Proposal: Approval of matters reserved for appearance, landscaping, layout and scale following outline planning permission S/1963/15/OL for residential development for up to 55 dwellings with landscape buffer and new vehicular access from Bartlow Road

Application Ref: S/2501/19/RM

Location: Land to the North and South of Bartlow Road, Linton, CB21 4LY

Further comments on Planning Application s/2501/19/RM - Land off Bartlow Road, Linton.

RELATIONSHIP OF THE TWO SITES, OVERLAYING SECTIONS CC AND FF

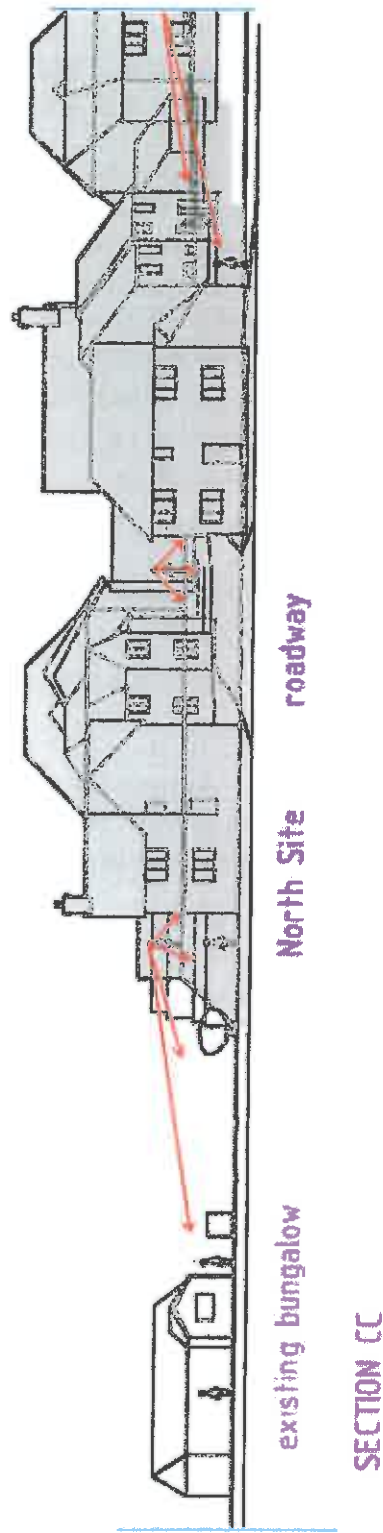
- The height differences between housing means that ground floor levels of some plots are at first floor (or higher) level to neighbours, with potential loss of privacy and overshadowing e.g. plot 1 is 3.9 m higher than plots 7,8,9. Plot 4 is around 3m above plot 21.

- Proposed housing will overshadow and overlook neighbours on Bartlow Road and within the site, with loss of amenity and privacy. See overlay which illustrates this.

CROSS SECTION F-F WITH EXISTING HOUSES ADDED - BARTLOW ROAD RM2 - LPC 5

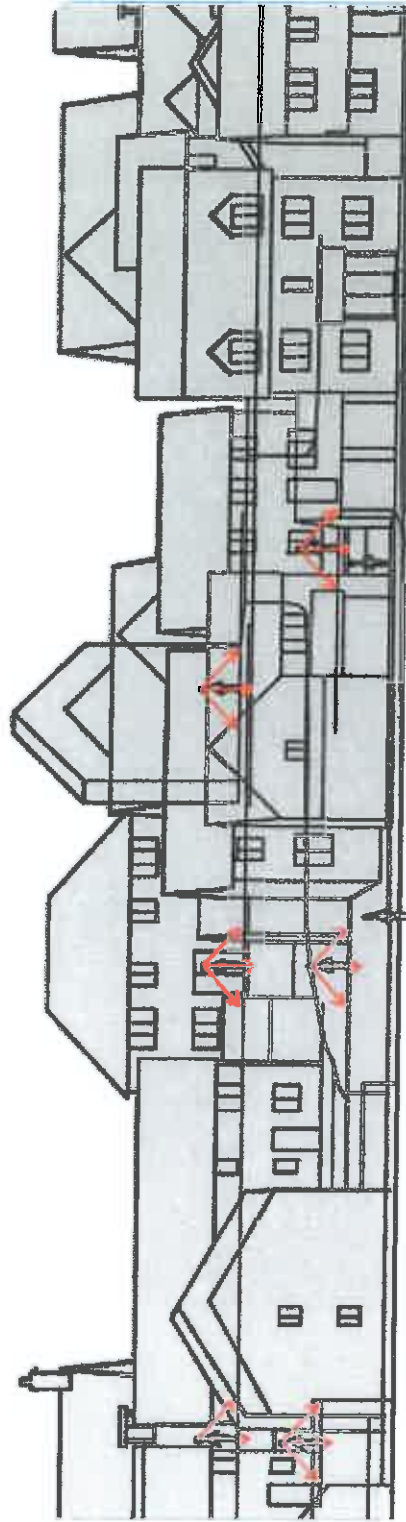
- The current housing along Bartlow Road will be overlooked by new houses opposite them, with the loss of their human right to privacy.
- The terraced nature of the development remains - 16 houses have terraces - shortened but still a prominent feature. The built up platforms are not shown and careful fading misleadingly minimise their effect on the views and landscape.

**Recorded Flood Event Outlines centred on Mill Lane, Linton, Cambridgeshire.
NGR TL 56463 46613. Ref 34305. Created on 16 January 2017.**

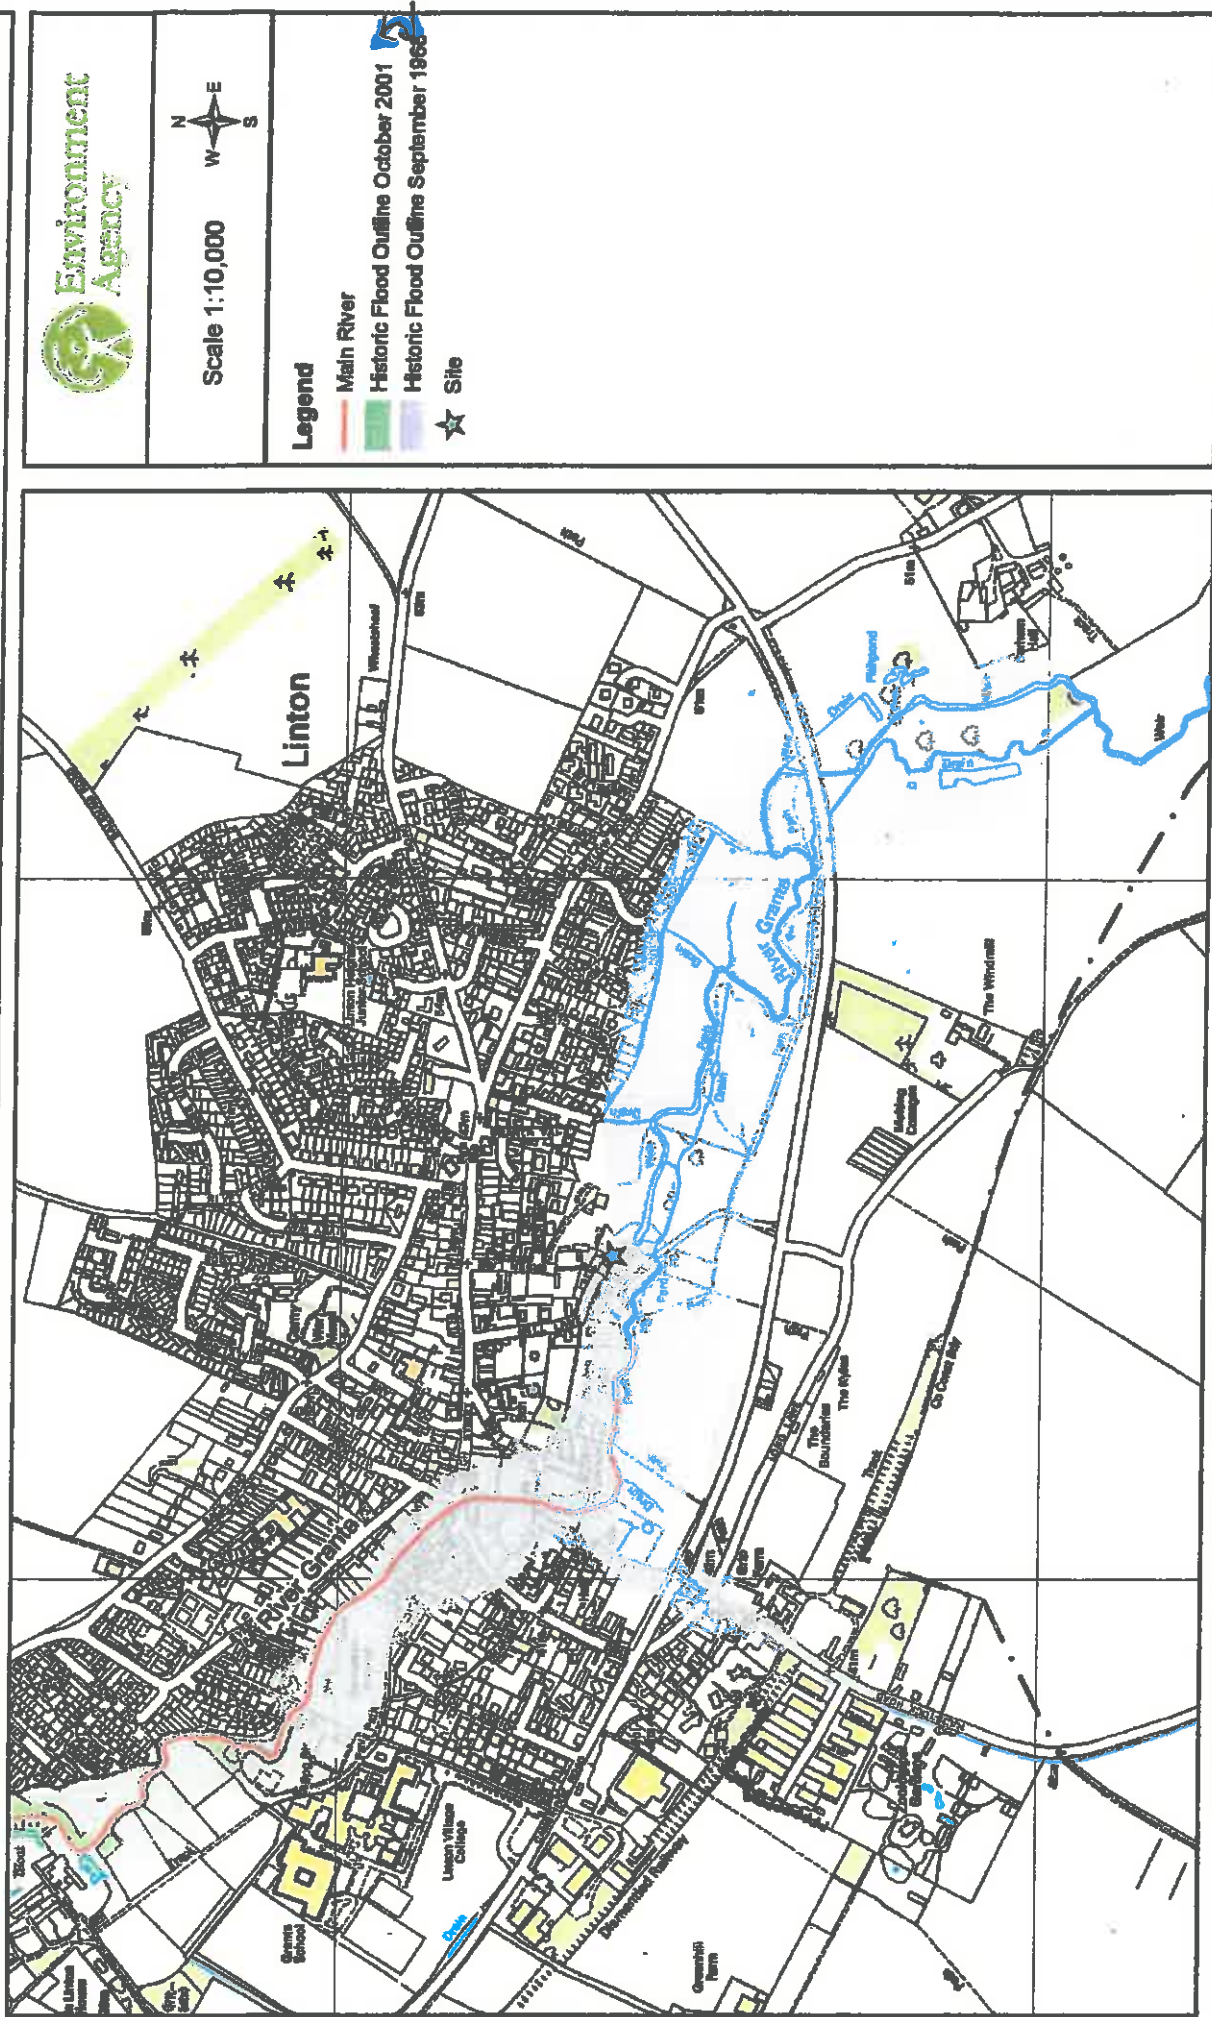
- The southern site is part of the floodplain. Reference to the updated EA maps and the SCDC flood maps in the LDP of 2010 (provided), show that part of the "developable area" of the site remains liable to flooding (Flood Zone 2). The ditches along the western edge of the southern site and behind Finchams are in Flood Zone 2, with the pumping station shown in area prone to this flooding.

- The maps used by the developer do not show the true extent of flooding, nor the nature of the flooding - water accumulates in the Ashdon area and comes downriver as flash flooding.
